寄件者: Chong Hermose [REDACTED]  
寄件日期: 2025年10月20日星期一 10:25  
收件者: tpbpd/PLAND  
副本: Andrea Wing Yin YAN/PLAND  
主旨: A/YL-KTN/1176 : 申請文件  
附件: A\_YL-KTN\_1176\_Approved FS\_Plan.pdf; A\_YL-KTN\_1176\_Approved  
Drainage Proposal..pdf; A\_YL-KTN\_1176\_補充資料 ( 運輸處 ) ..pdf

**1. Comments from DSD**

# TEMPORARY DRAINAGE PROPOSAL

Application Site of Proposed Temporary Private Club for a  
Period of 3 Years in Lot 130 Rp in D.D.110 and Adjoining  
Government Land, Kam Tin, Yuen Long, New Territories  
Issue 3 (November 2024)

Swept Path (In)

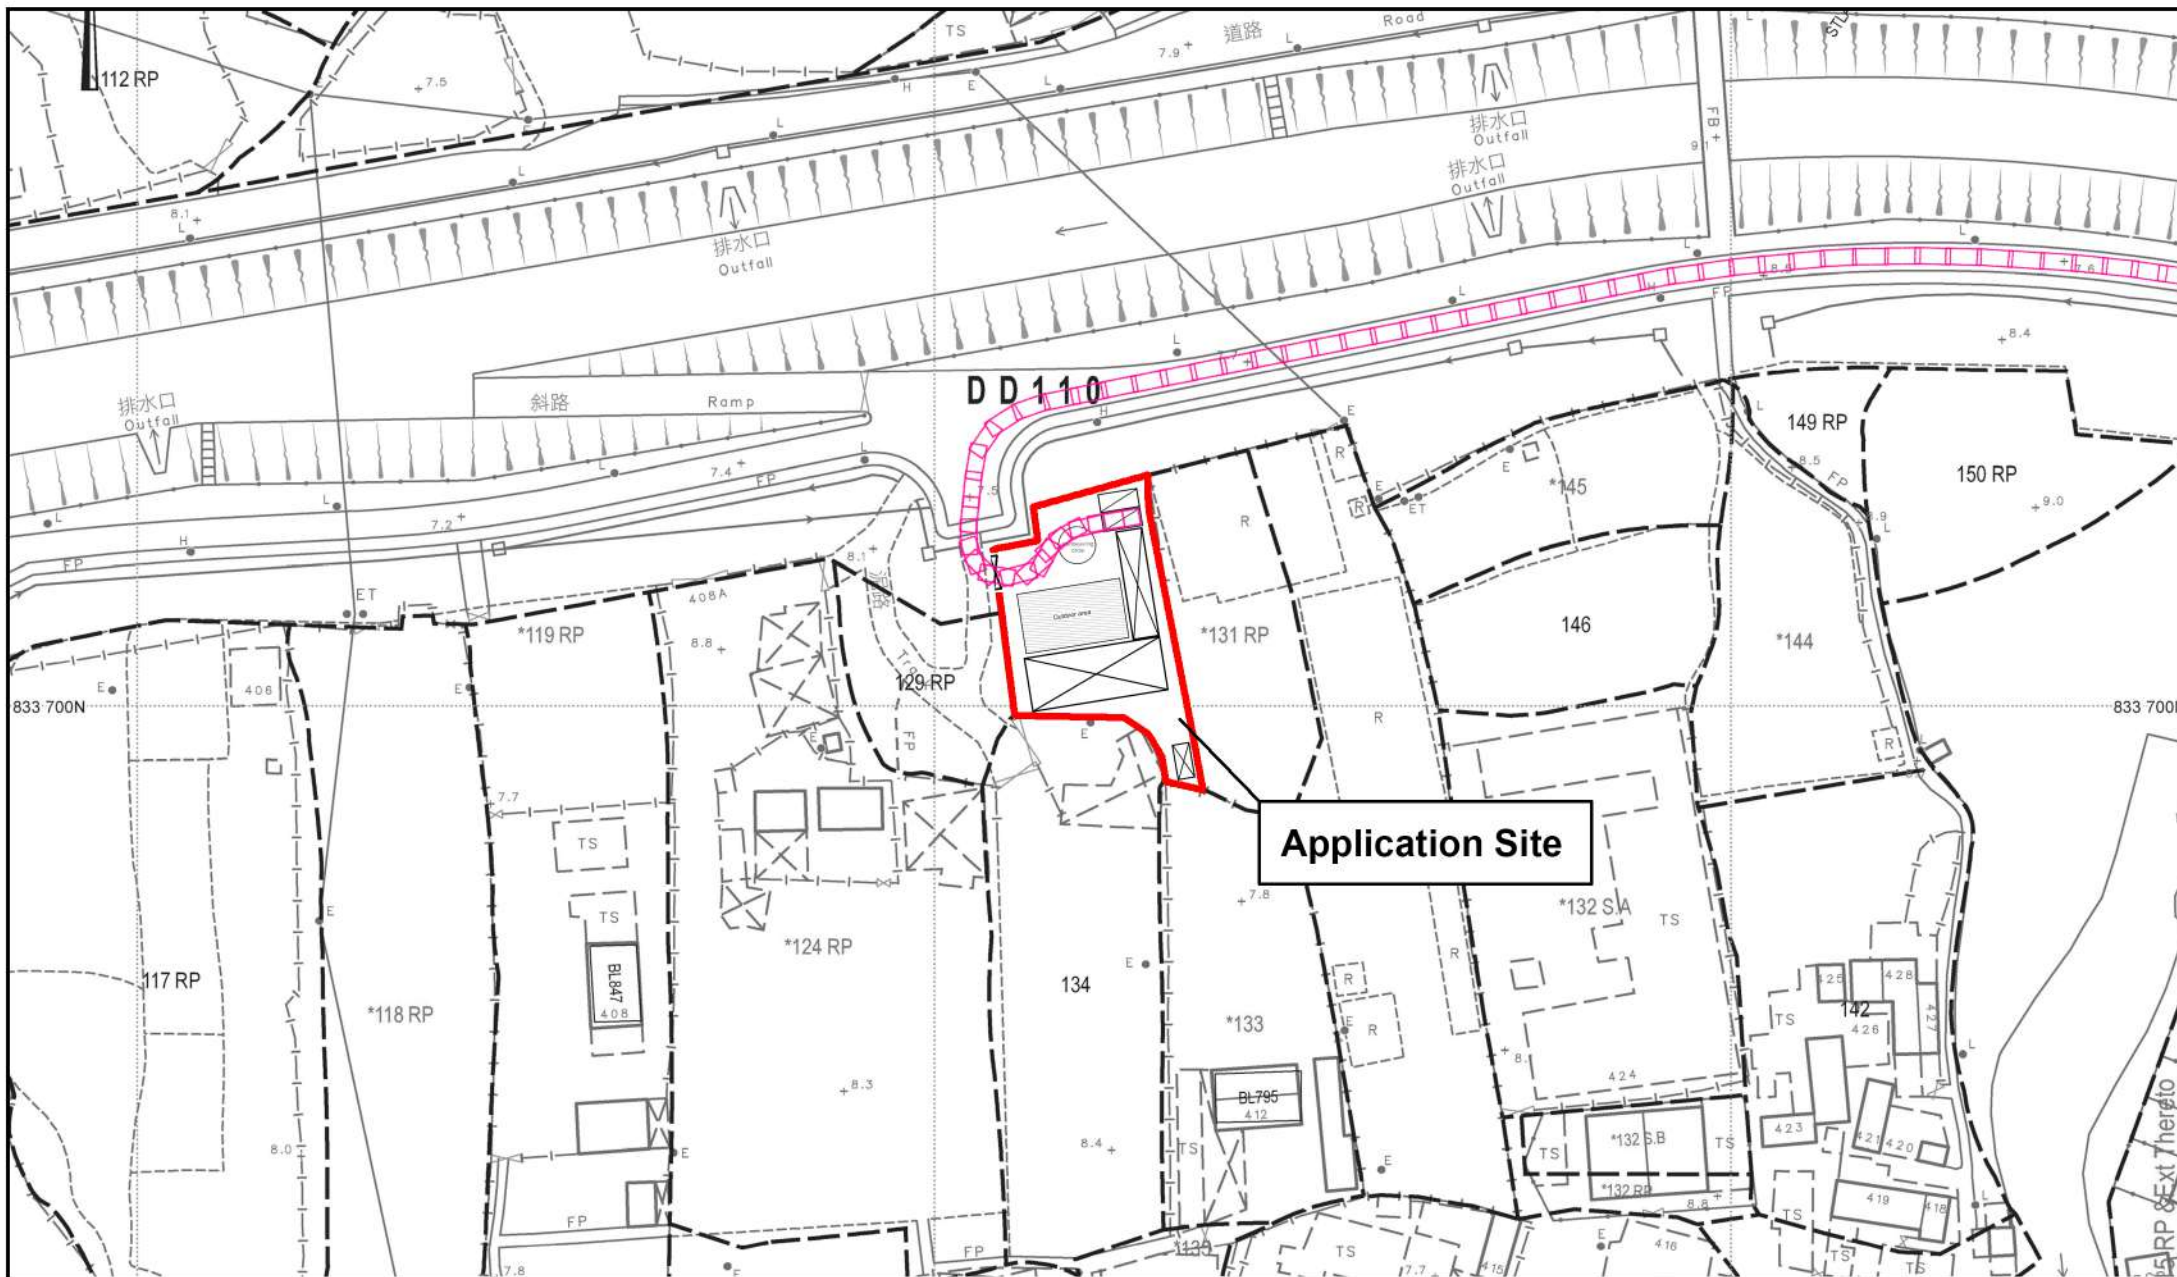
|     | Departmental Comments                                                                                                                   | Responses                                   |
|-----|-----------------------------------------------------------------------------------------------------------------------------------------|---------------------------------------------|
| (a) | The applicant should demonstrate the smooth maneuvering of vehicles to / from Kam Tai Road, along the local access and within the site; | 請看附件 1 : Swept Path 。                       |
